To:	All plan holders	From:	Tracy Bruun, Division
Pages:	15	Phone:	515-344-6279
Re:	Car853313A Nutrient Reduction Wetland (Bid No. 25-13)	Date:	October 3, 2025

Subject: **Addendum No. 1** to Bid Documents  
CAR853313A Nutrient Reductionl Wetland Project – Bid No. 25-13  
Carroll County, Iowa

SS  
Attachment No. 1 – Updated Document CC  
Attachment No. 2 – Updated Plan Sheets U.1 and U.2.

**PZC 13 SHEET PILE CROSS-SECTION**  
SCALE: N.T.S.

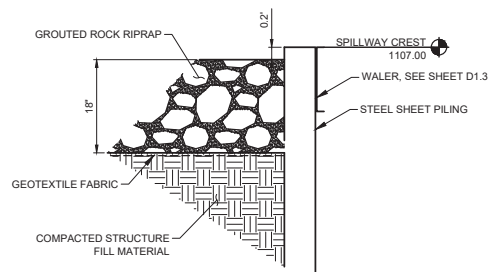
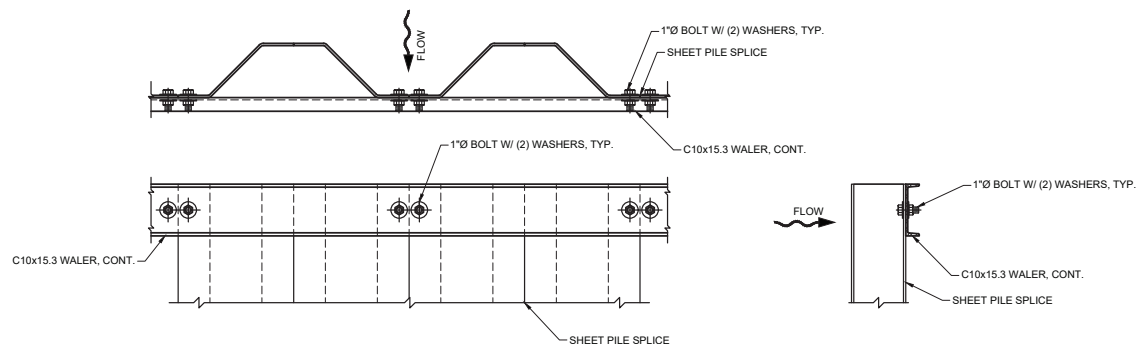
- See revised Plan U.1, with the corrected sheet pile quantity of 2,595 SF.
- See revised Plan U.2, with a note that the stoplogs must be aluminum.

1. DESIGN SHEET PILE AREA = 2.595 SF
